Our Case Number: ACP-324410-26

Re: Proposed West Clare Railway Greenway Section 1: Kilrush to Kilkee Project
Kilrush to Kilkee via Moyasta, Co. Clare

Ref: Compulsory Acquisition of Land – Clare County Council
West Clare Railway Greenway Section 1: Kilrush to Kilkee
Compulsory Purchase Order 2026

West Clare Railway Greenway Section 1: Kilrush to Kilkee

Figure 2 – Frances Street WWPS to Kilrush WWTP rising main

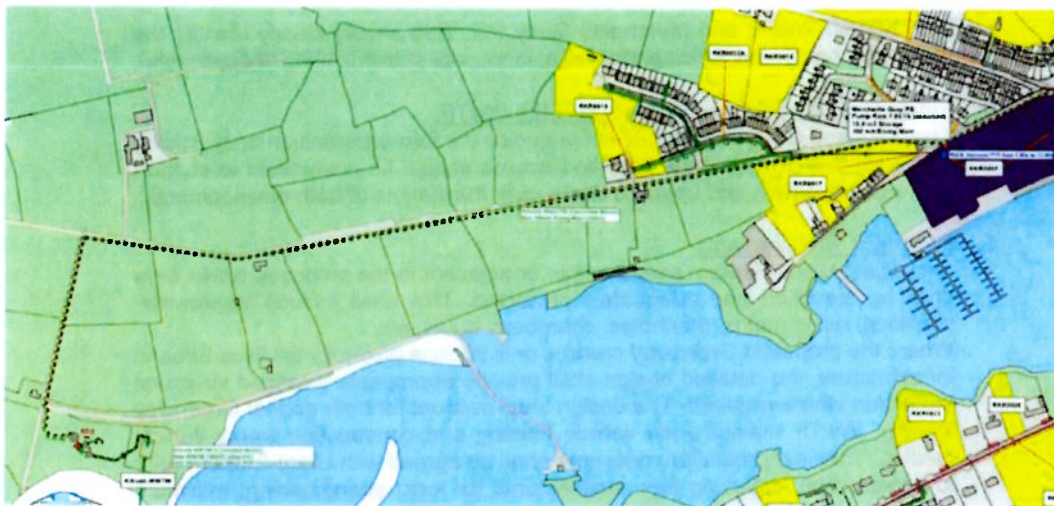
9. A fully accessible wayleave over the 400 HDPE rising main is required (the rising main is indicated by the dotted line in Figure 2 below).

10. A fully accessible wayleave over the 400mm HDPE rising main is required.
11. This wayleave should be recorded as a burden on the folio/s in question.
